ADDENDUM NO. 3

EXETER, NEW HAMPSHIRE

CONTRACT NO. 1 – WASTEWATER TREATMENT FACILITY UPGRADES

FEBRUARY 2017

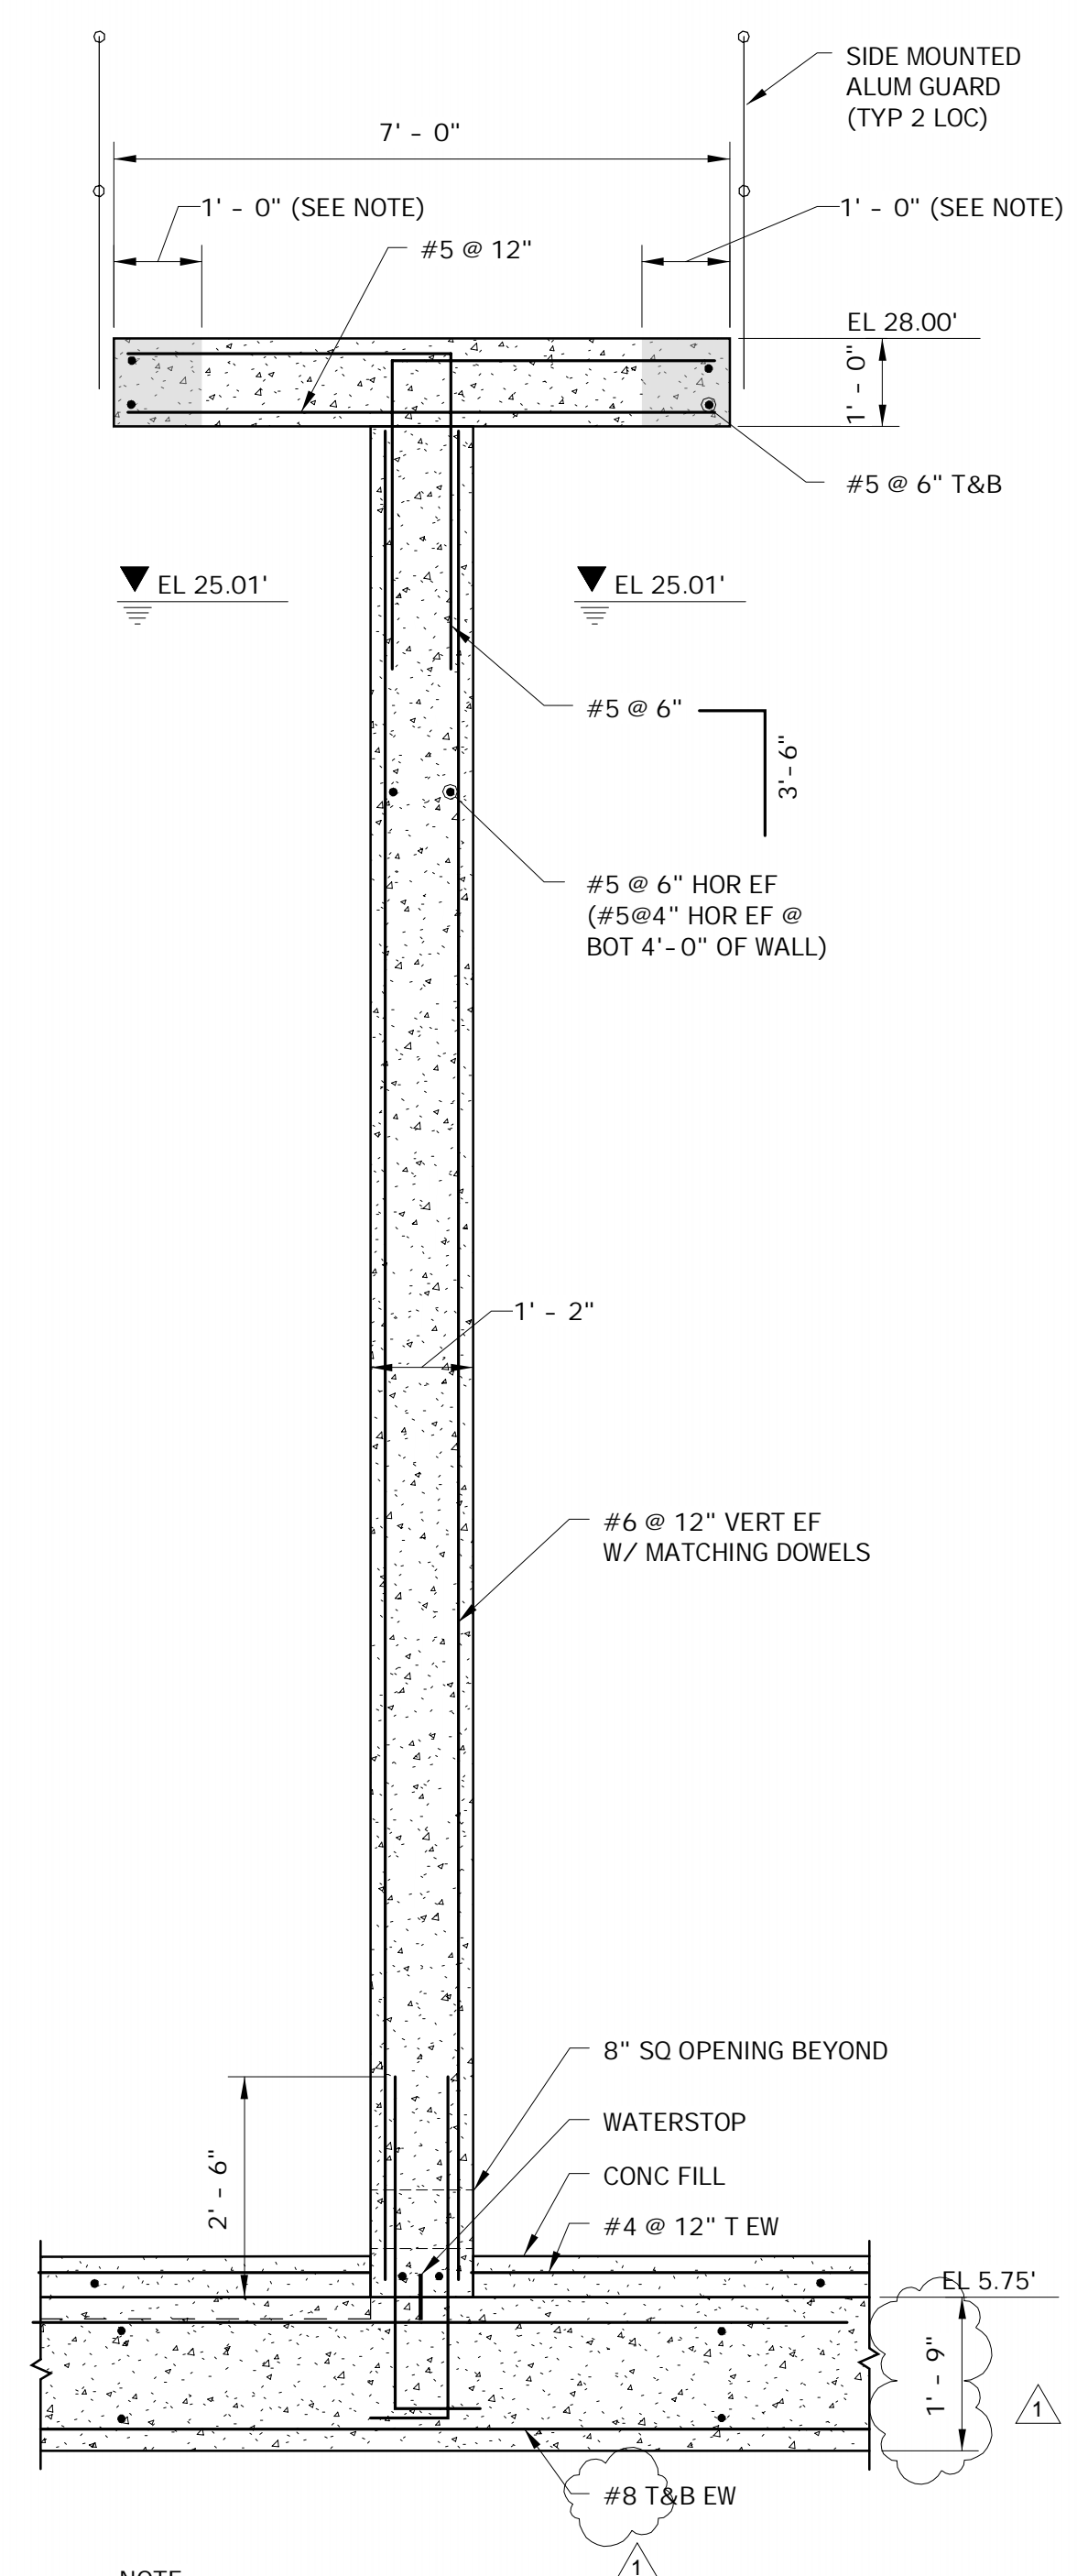
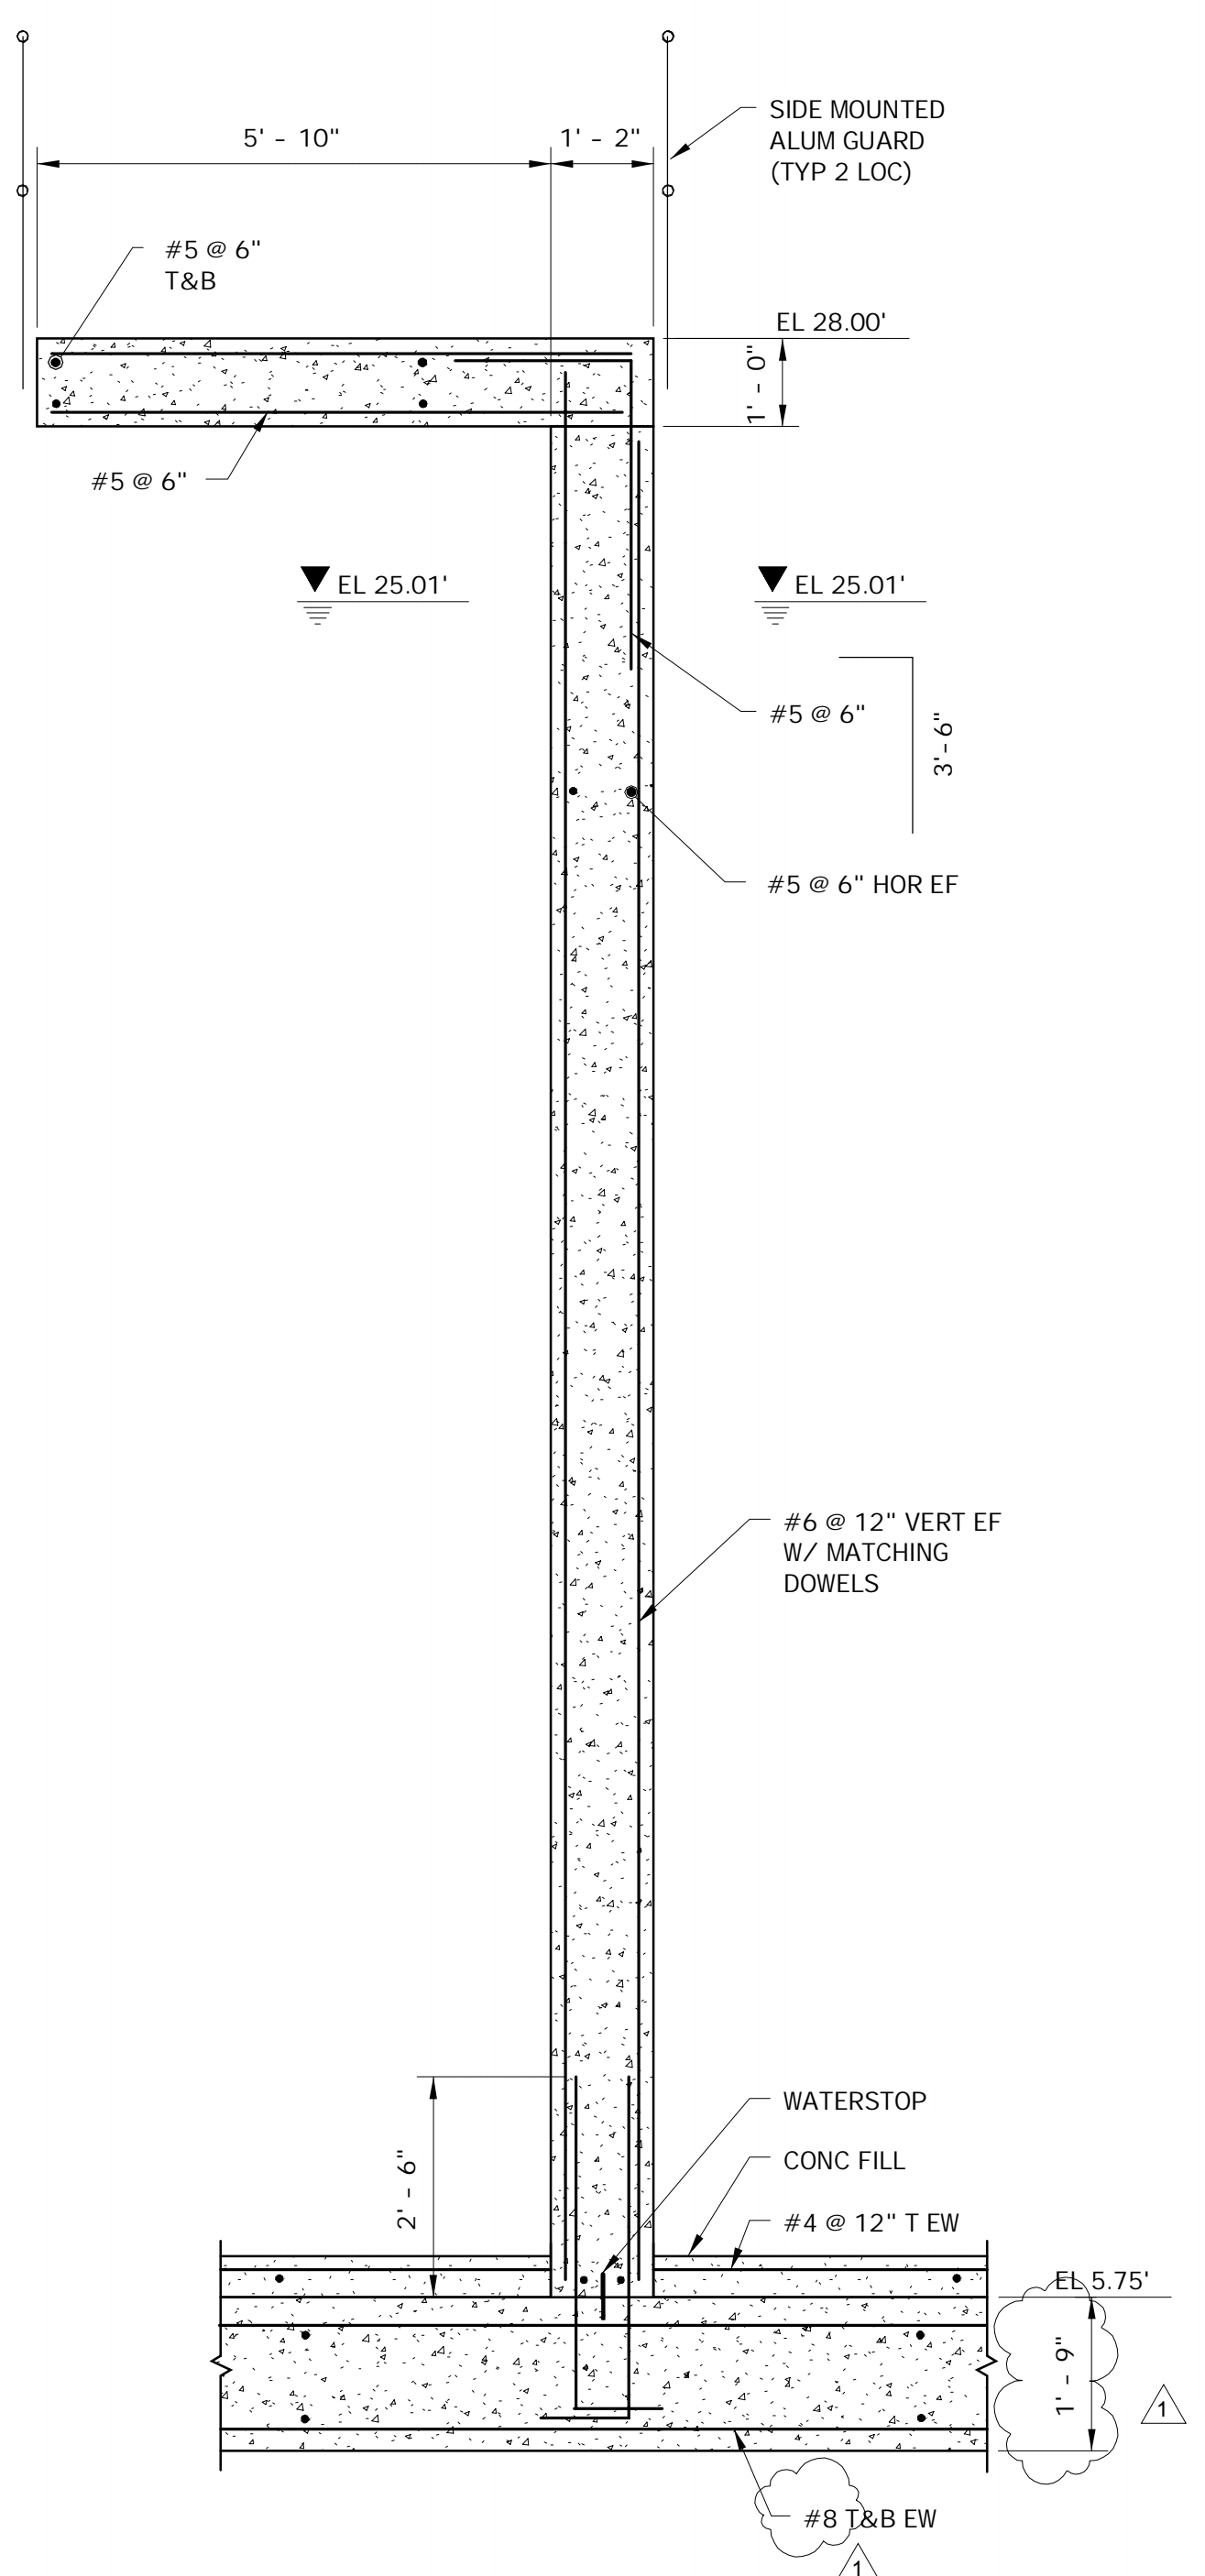
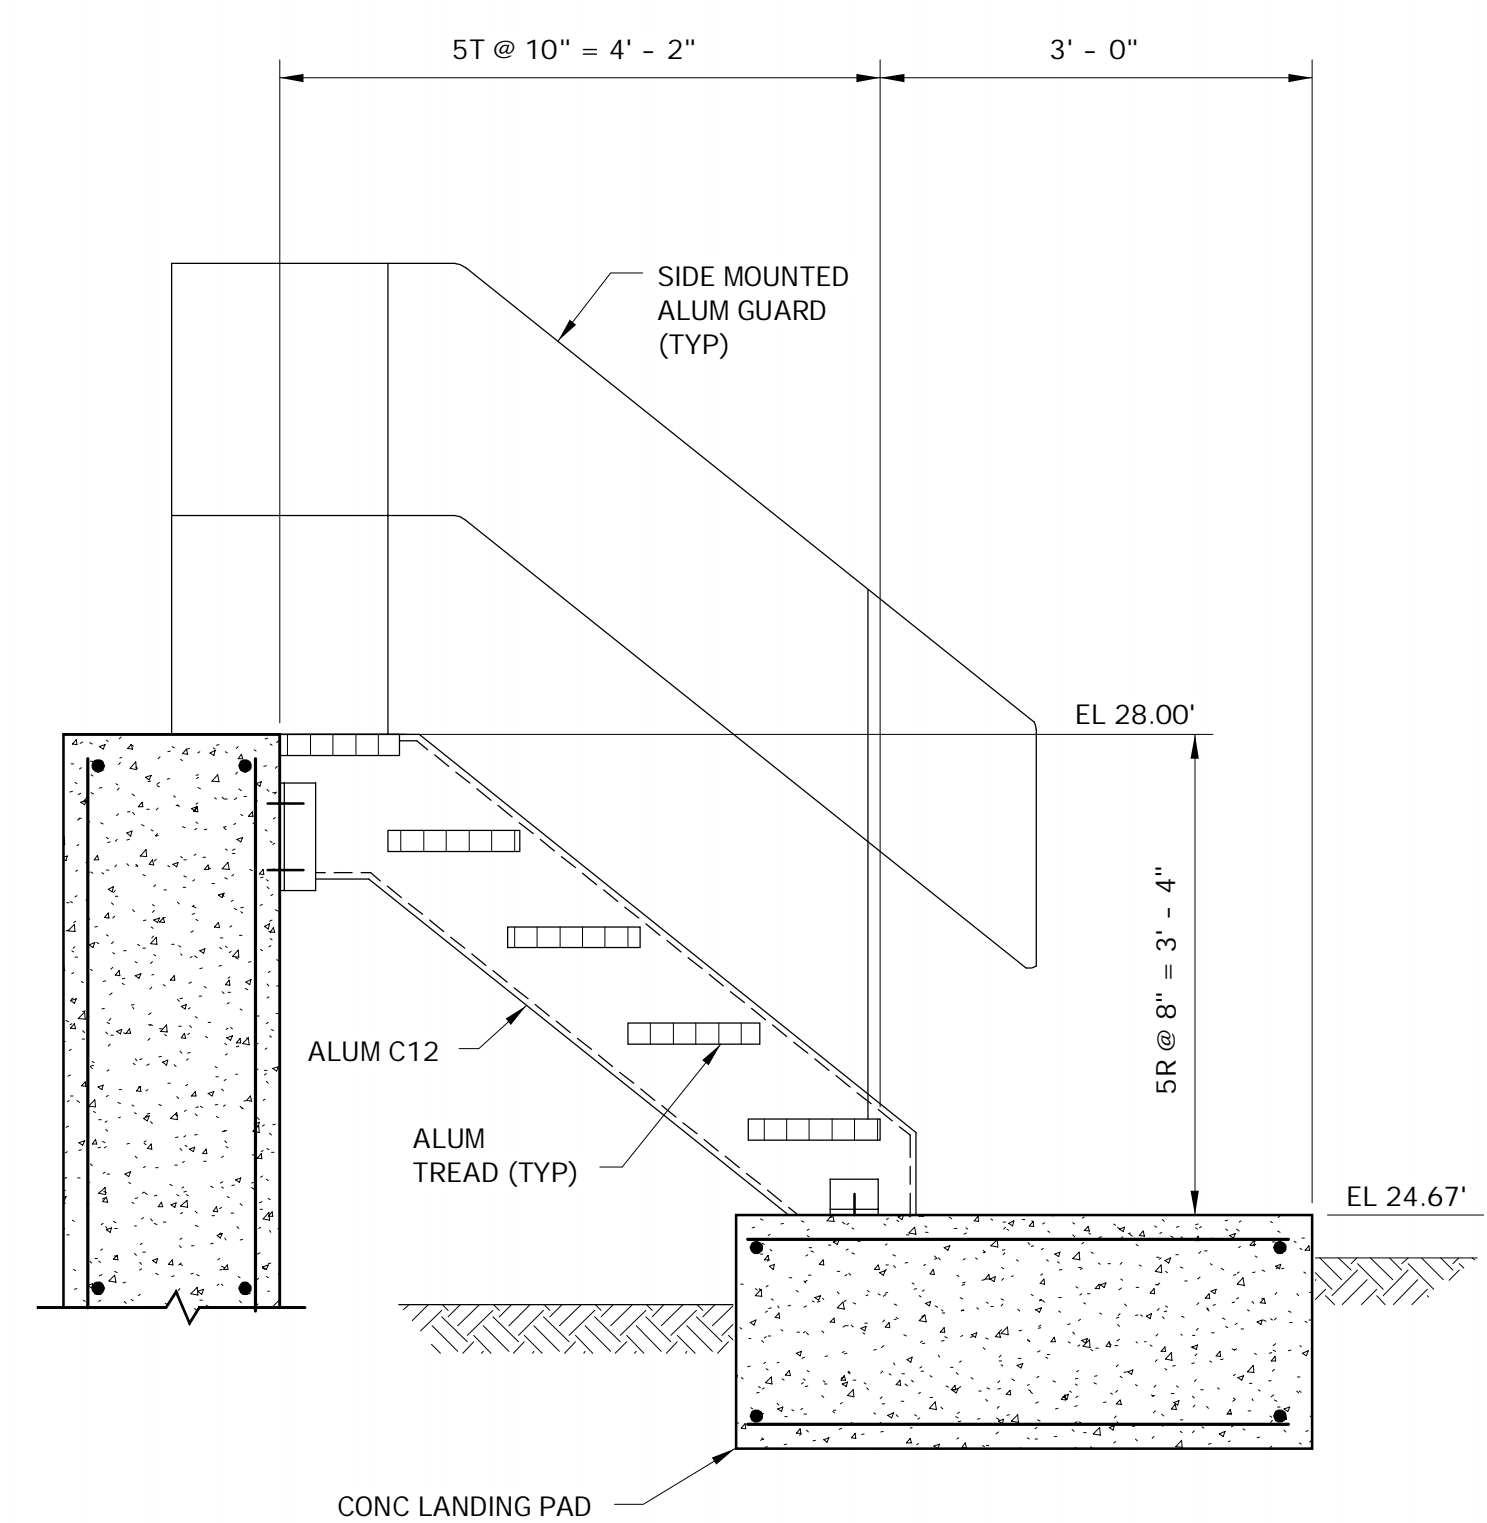
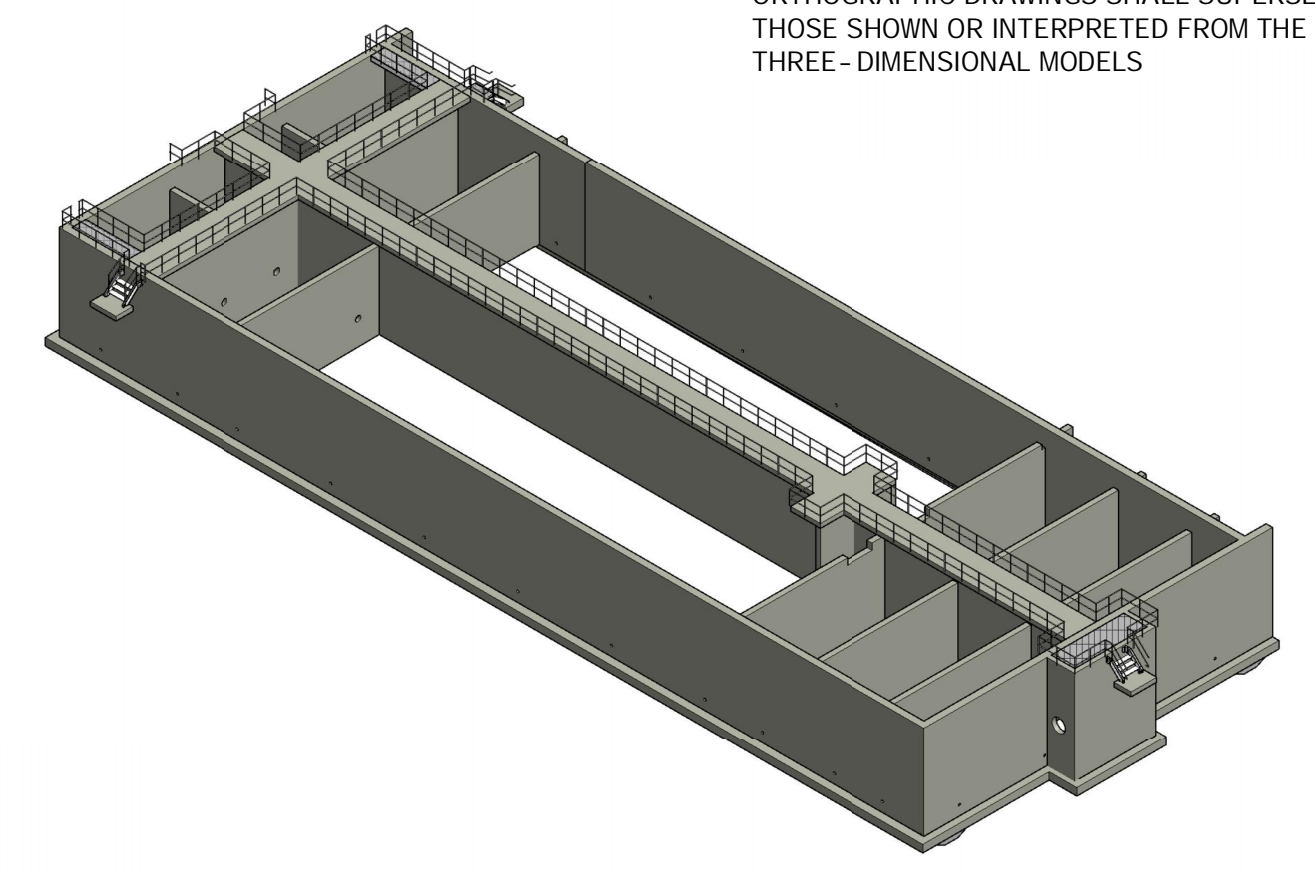
9. Drawing S-26, Aeration Tanks. **DELETE** the drawing and **REPLACE** with the attached version.
10. Drawing S-27, Aeration Tanks. **DELETE** the drawing and **REPLACE** with the attached version.
